Corrine Drive Study – Answers to Community Questions Part 2

Approximately 200 questions were submitted at the Corrine Drive Community Meeting May 1. About half were answered in Part 1, a document currently available www.corrinedrivestudy.org. This document answers the rest of the questions, plus additional questions asked since the May 1 meeting.

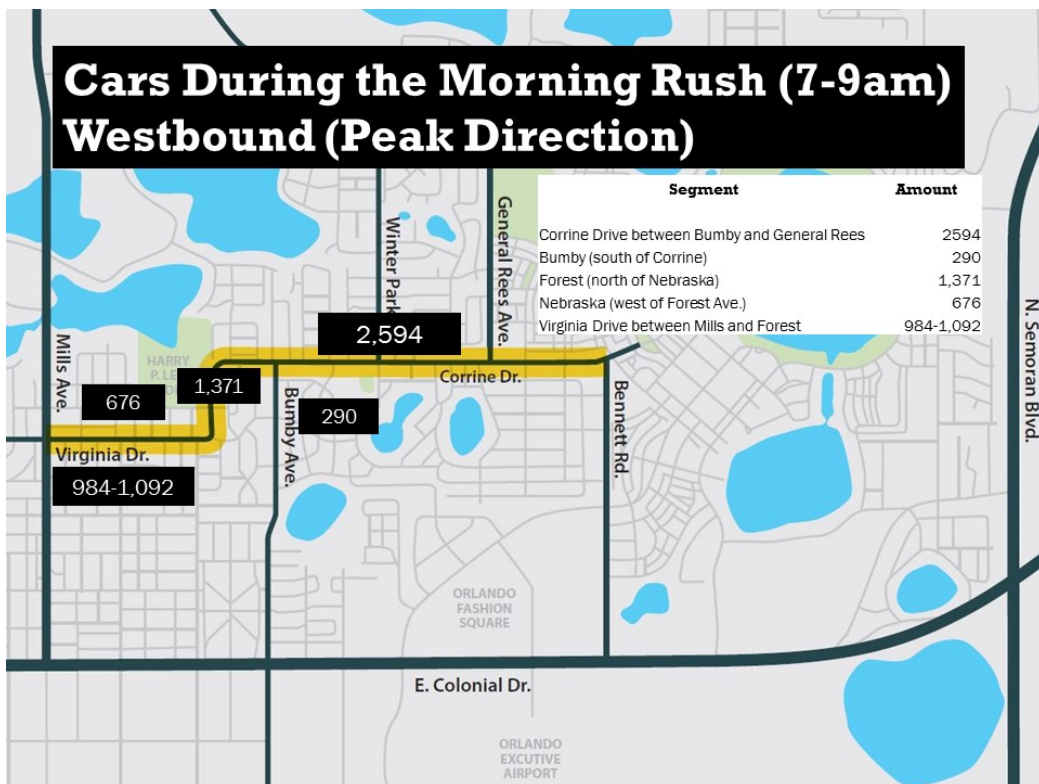
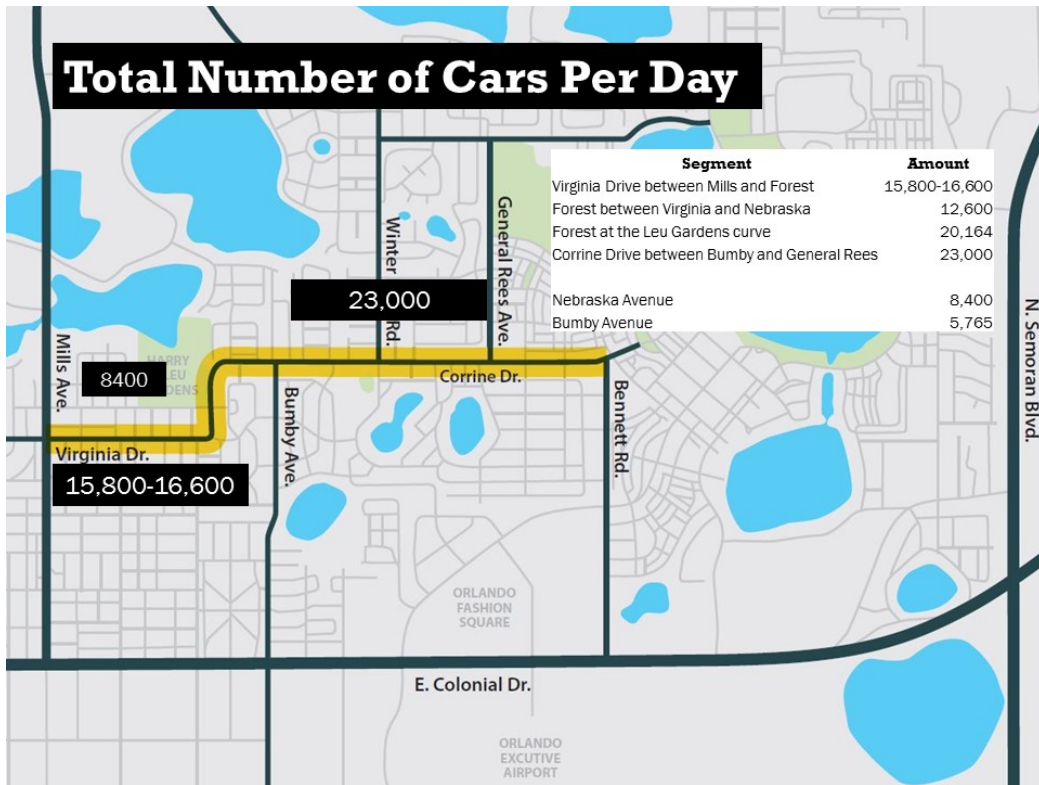
- *Shouldn't Nebraska be widened to divert traffic bottlenecks away from the reduced lanes on Virginia?*
- *It would seem that by narrowing down going north on Forest as you approach Nebraska that having a dedicated lane to turn right on Nebraska will substantially increase traffic on Nebraska that would be unfortunate as the traffic is very heavy during "rush" hour now. What do your models show on this issue?*

- *You stated that the new 3-lane design can handle the traffic, but it is already backed up to Nebraska from Mills Ave to Nebraska at rush hour. How is this possible? Also, have you taken into consideration the increased traffic expected over time?*

- *For people driving down Corrine to Mills, are you worried that the shift from 5 lanes to 3 at Nebraska will encourage traffic into Nebraska to avoid congestion. This could cause more traffic intersection over the shared use path at Nebraska.*

- *Why are you pushing traffic onto Nebraska?*
- *Why would a road engineer think that creating a choke point between Nebraska and Mills? This makes absolutely no sense at all (Nebraska doesn't want more traffic)*

- *How will chokepoint at Mills and Virginia affect traffic on Nebraska?*
- *Will the 3 lane design affect Nebraska's traffic. Its already a busy street.*

MetroPlan Orlando does not expect Nebraska St. to experience an increase in traffic volume. Nebraska, as it is today, has the capacity to support the number of cars who use it today and the number expected to use it in the future with the Recommended Design. Widening the street is not needed. There are a few reasons for this:

- The 3-Lane Design has the capacity to handle about 20,000 cars a day. About 16,000 cars use the street today. That's space for an additional 4,000 cars each day.
- About 8,400 cars currently use Nebraska and these cars travel the speed limit.
- While Nebraska has two travel lanes, it does not have the same capacity as the Virginia Drive section of the Recommended Design. This is due to its lack of a center turn lane. But the street does have the capacity for at least 17,000 cars. This is double what it currently carries.
- About 40% of the cars that use Corrine Drive north of Nebraska, use Nebraska to reach Mills Ave.

The Traffic Counts Maps at the end of this FAQ highlight these traffic volumes as well.
